Product Change Notice (PCN)

Subject: Transfer Assembly Location from OSET, Taiwan to Greatek, Taiwan on Select Packages

Publication Date: 2/27/2020

Appendix C – Package Outline Drawing Comparizon, SOJ28

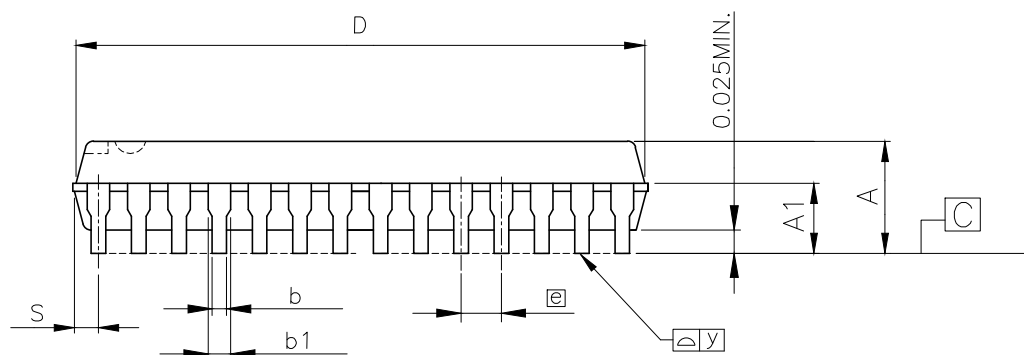
The material sets of the current and new assembly locations are as shown in the below table. The package outline drawing for SOJ28 assembled at Greatek, Taiwan will not meet JEDEC on select dimensions. Refer Appendix C.

Symbols	JEDEC			exIDT POD			Greatek POD			Remark
	MO-088			MO-088			NA			
	MIN	NOR.	MAX	MIN	NOR.	MAX	MIN	NOR.	MAX	
A	0.120	-	0.140	0.120	0.130	0.140	0.120	-	0.140	Greatek meet JEDEC/exIDT
A1	-	-	-	0.078	0.086	0.095	0.820	-	-	Greatek not meet exIDT
A2	0.025	-	-	0.025	-	-	0.025	-	-	Greatek meet JEDEC/exIDT
b	0.014	-	0.020	0.014	-	0.020	0.016	0.018	0.022	Greatek not meet JEDEC/exIDT
c	0.008	-	0.013	0.008	-	0.013	0.008	0.010	0.014	Greatek not meet JEDEC/exIDT
D	0.697	-	0.712	0.700	0.706	0.712	-	0.710	0.730	Greatek not meet JEDEC/exIDT
H	0.335	-	0.347	0.335	0.340	0.347	0.327	0.337	0.347	Greatek not meet JEDEC/exIDT
E	0.292	-	0.300	0.292	0.296	0.300	0.295	0.300	0.305	Greatek not meet JEDEC/exIDT
e1	0.262	-	0.272	0.262	0.267	0.272	0.245	0.265	0.285	Greatek not meet JEDEC/exIDT
e	-	0.050	-	-	0.050	-	0.044	0.050	0.056	Greatek meet JEDEC/exIDT

However, the footprint will remain unchanged as compared to the existing package assembled at OSET.
